INFRASTRUCTURE AVAILABILITY REPORT

Block F
Infrastructure Availability Report

Honolulu, Oahu, Hawaii
Tax Map Key: 2-1-053:Por.001

Prepared by
Wilson Okamoto Corporation
1907 South Beretania Street, Suite 400
Honolulu, HI 96826

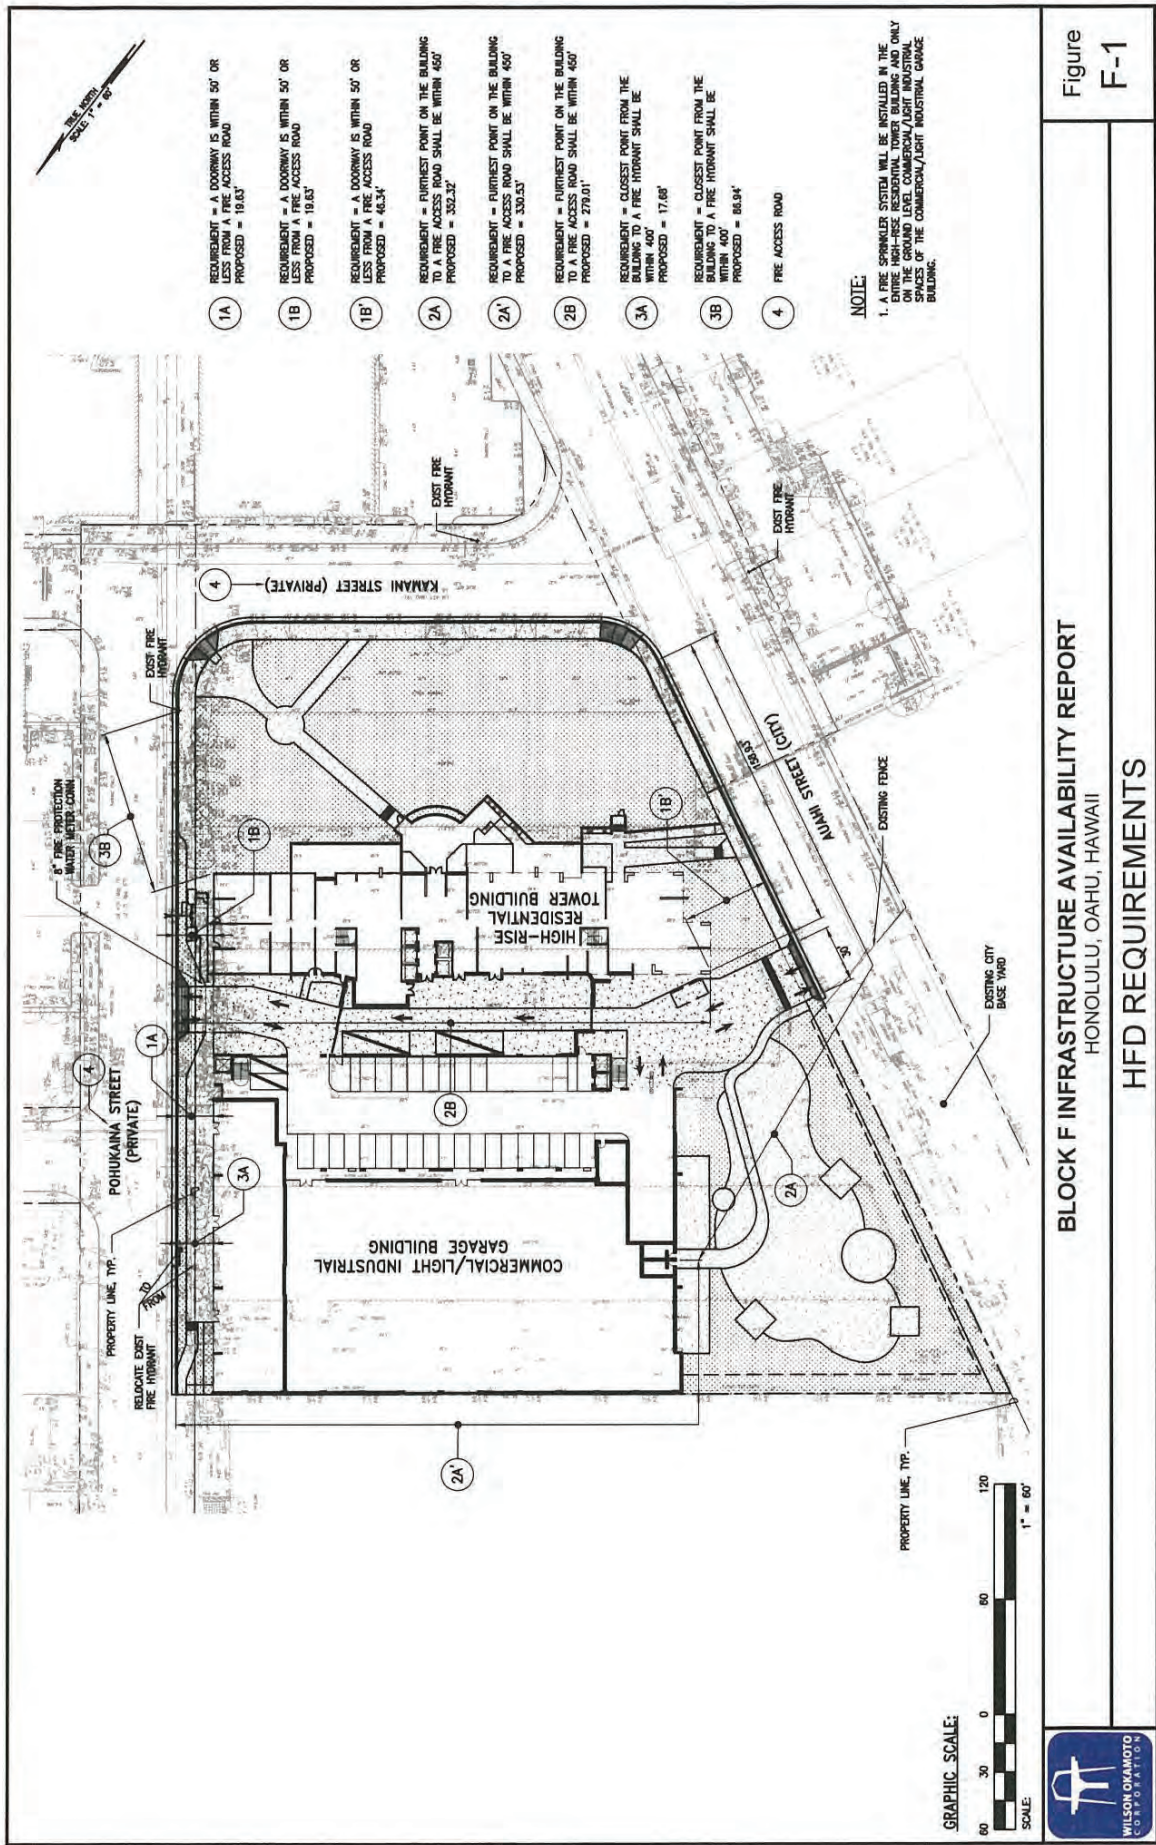
Hello Rika,
If the commercial/light industrial building will only be sprinklered on the 1st floor, then the fire flow requirement will be as specified in table 18.4.5.1.2 of the 2012 NFPA 1. The fire flow requirement is reduced if the building is sprinklered throughout, not only partially.
Ricardo

Ricardo,
We have updated the note in our figure because the architect had pointed out that only the ground level of the commercial/light industrial spaces will have the fire sprinkler system, not the rest of the garage.
Does this change make a difference?

Rika,
Great question, But no that is not a problem. The fire trucks can take Kamani street and continue onto Pohukaina Street.
Thanks,
Ricardo

Layout looks Good!

Hi Ricardo,
The required fire flow will be provided.
Does any of this affect the dimensions that were sent to you previously? Or, is the proposed layout still acceptable?
Please let me know.
Thanks,
Rika Okino
Civil Engineer
